# FINAL DRAFT MINUTES

**February 19, 2015 Standards Committee Meeting**  
(Changes to the Agenda and First Draft Minutes by the Action of the Committee shown highlighted **yellow**)

RE: Minutes from the February 19, 2015 Standards Committee Meeting

808-MKPM-07 PAVEMENT MARKING FOR RAILROAD CROSSINGS (WITH MARKUPS)

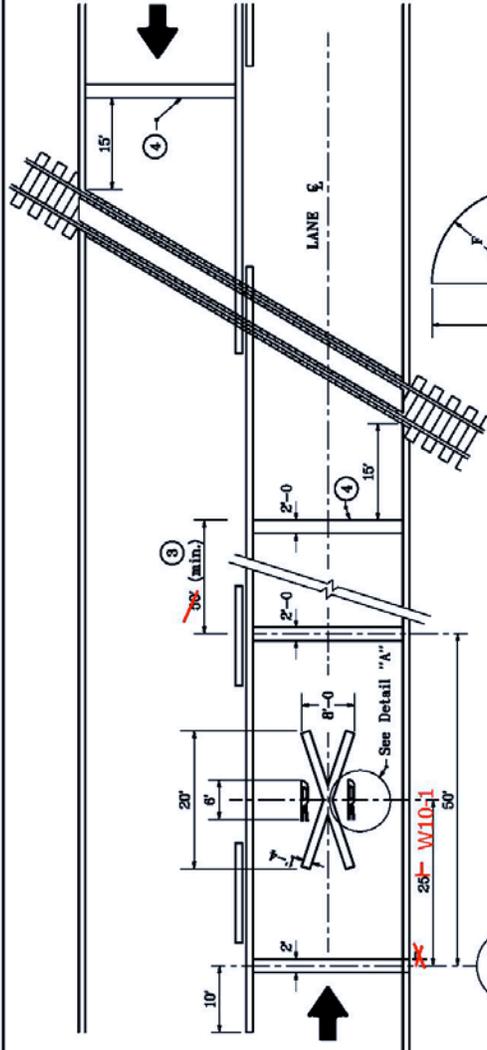
This item was introduced and presented by Mr. Boruff who proposed to create standard drawing sheets for fish-hook arrows and yield lines and update the remaining drawings in the series, and to revise pay items as shown on the proposal sheet. Mr. Bruno provided further clarification that what is presented is so that our standards will be in accordance with the MUTCD, and that the pay items in 808 will not need to be changed.

808-MKPM-05 TRANSVERSE MARKINGS YIELD LINES (PROPOSED DRAFT)

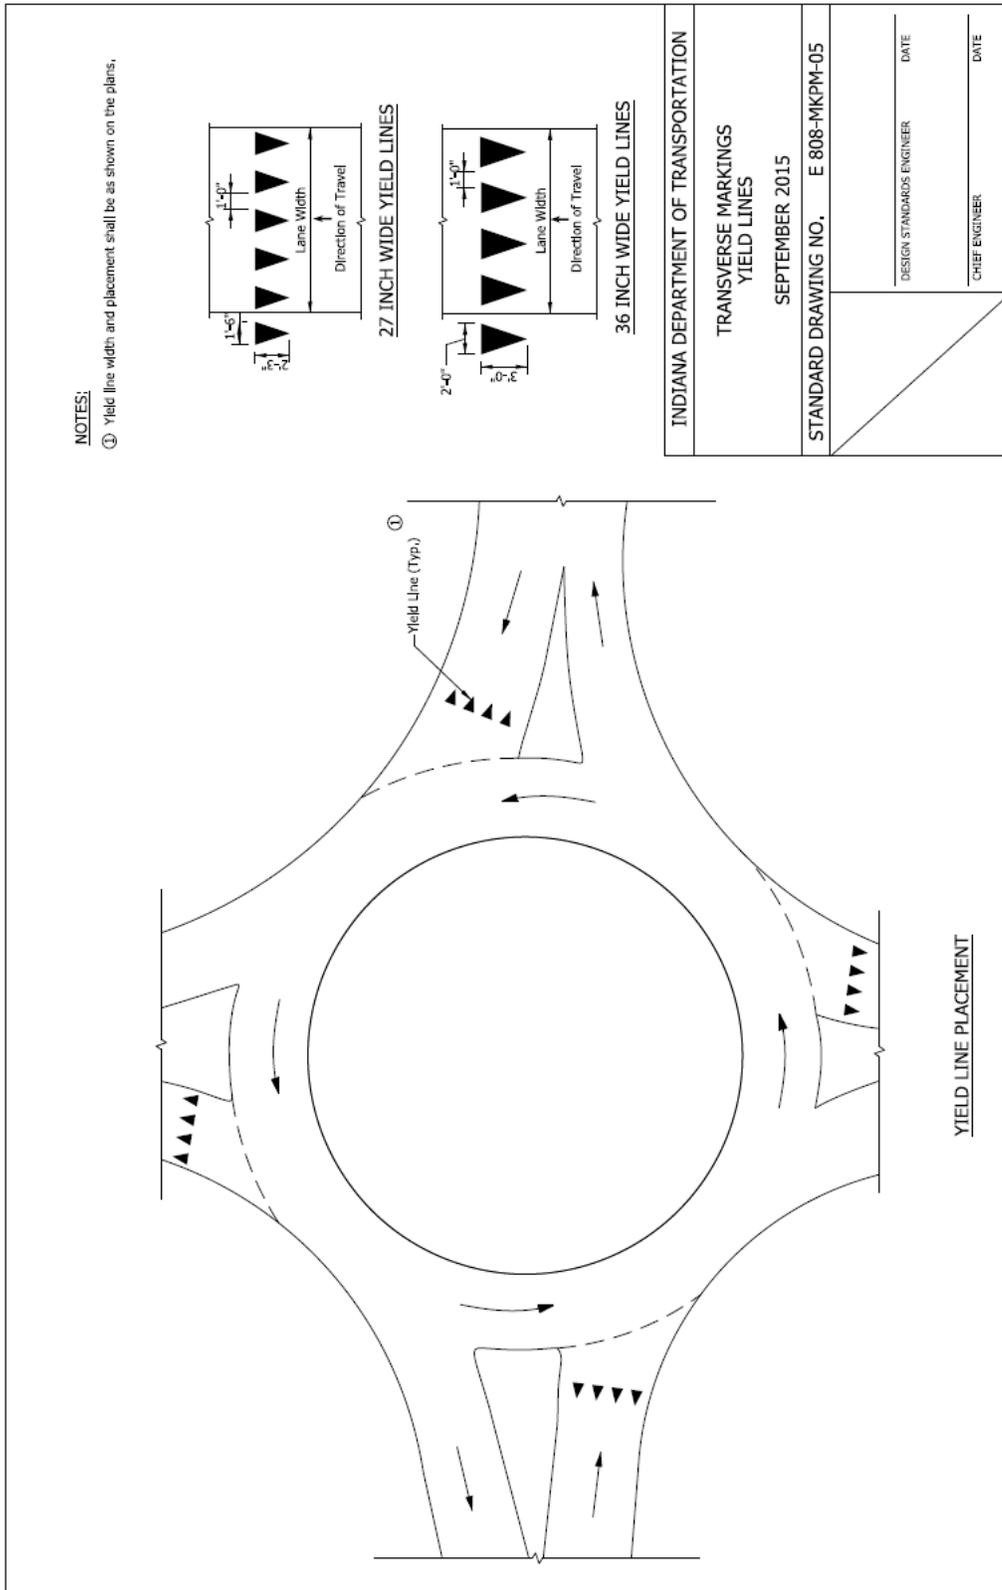
PROPOSED SOLUTION: Create a standard drawing sheet for fish-hook arrows and yield lines and update the remaining drawings in the series.

805-SGSC-04 SIGNAL POLES SPAN, CATENARY & TETHER DETAIL (WITH MARKUPS)

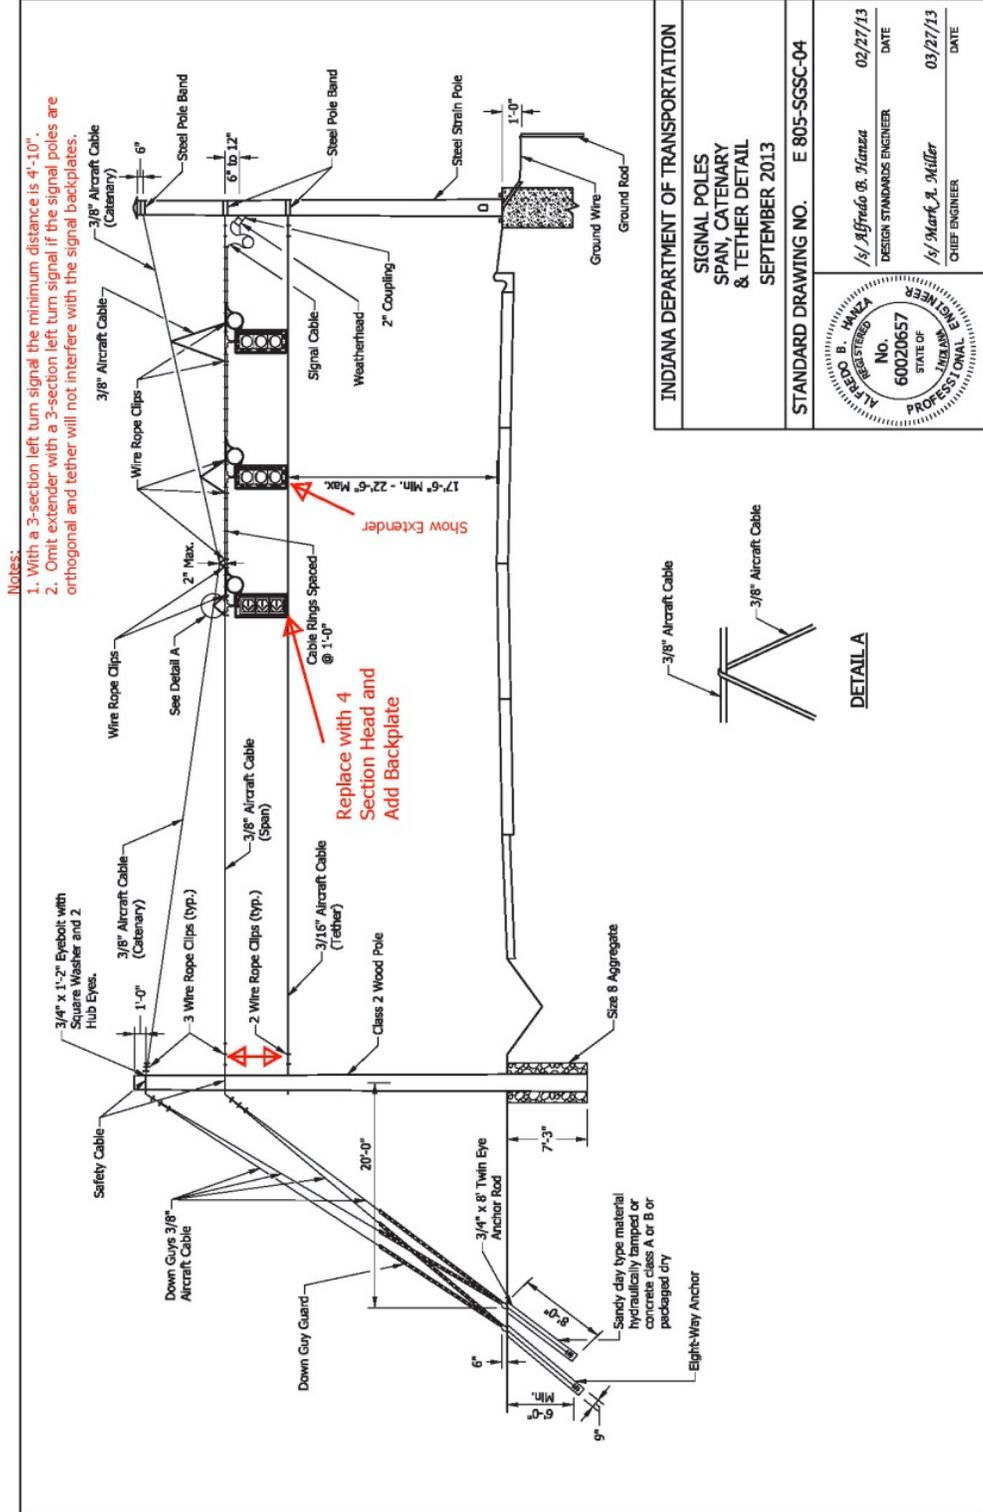
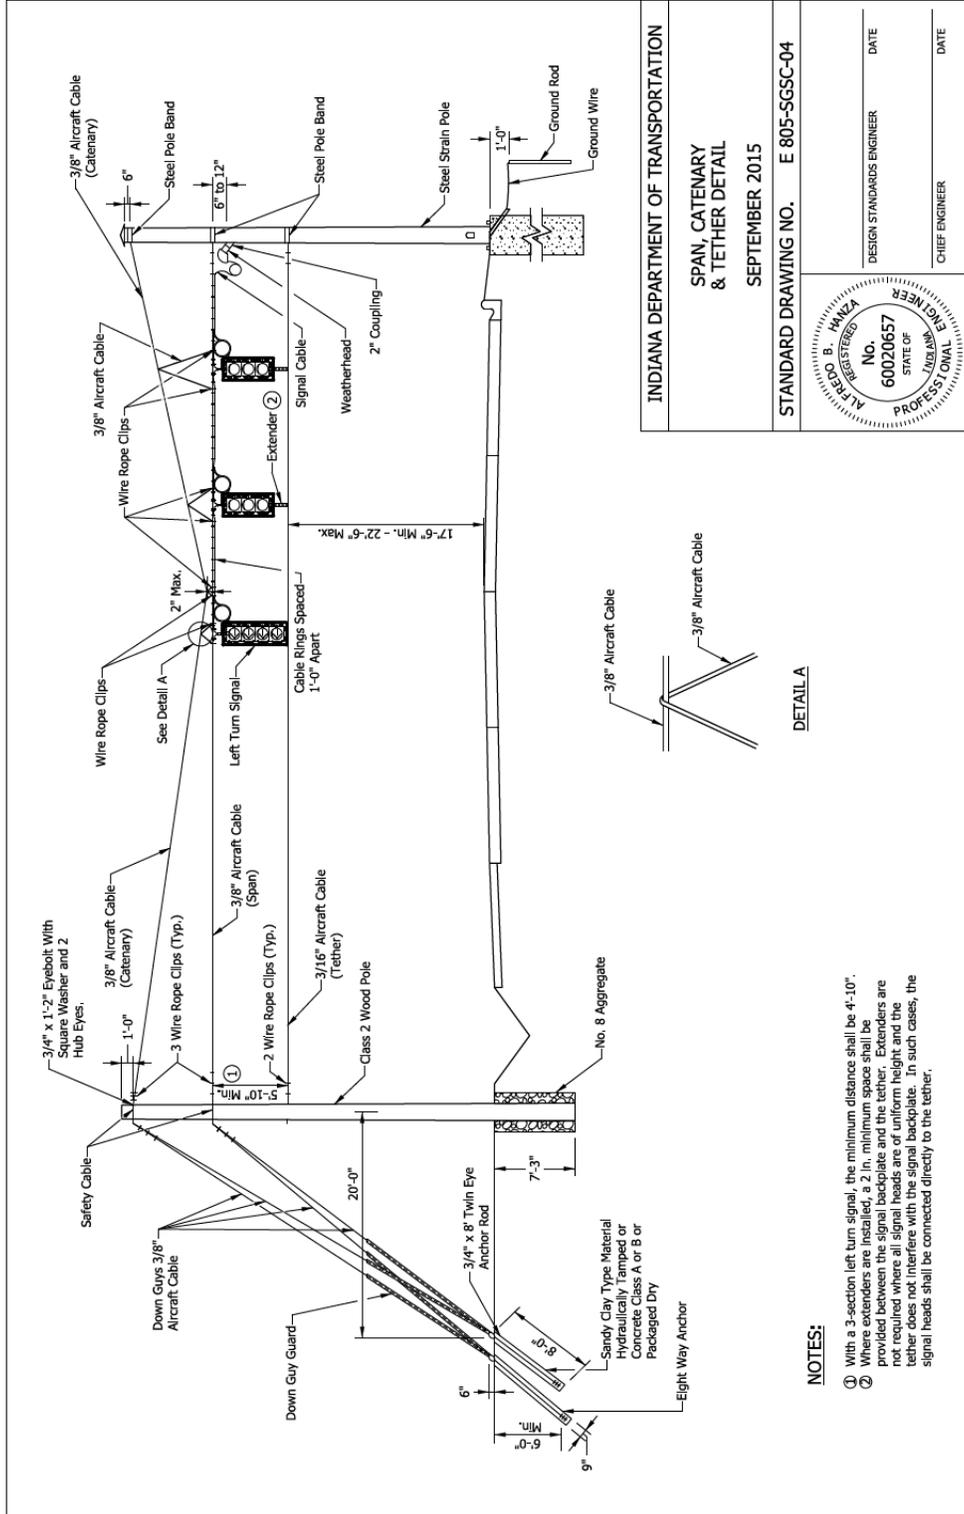
Mr. Boruff introduced and presented this item stating that the current specification only requires signal backplates on signal heads for the thru lanes. On most contracts with signal work, this provision is now being overridden to require backplates on all signal heads mounted overhead. Mr. Boruff therefore proposes to revise the construction requirements for signal heads to specify backplates on all traffic signal heads that are mounted overhead and attached to new structures.

~~Overhead three section~~  
*Except for signal heads installed on existing traffic signal cantilever structures, all overhead signal heads for through lanes shall have backplates, unless otherwise indicated on the plans with the exception of signal heads installed on existing traffic signal cantilever structures. Backplates shall not be cut or altered upon installation.*
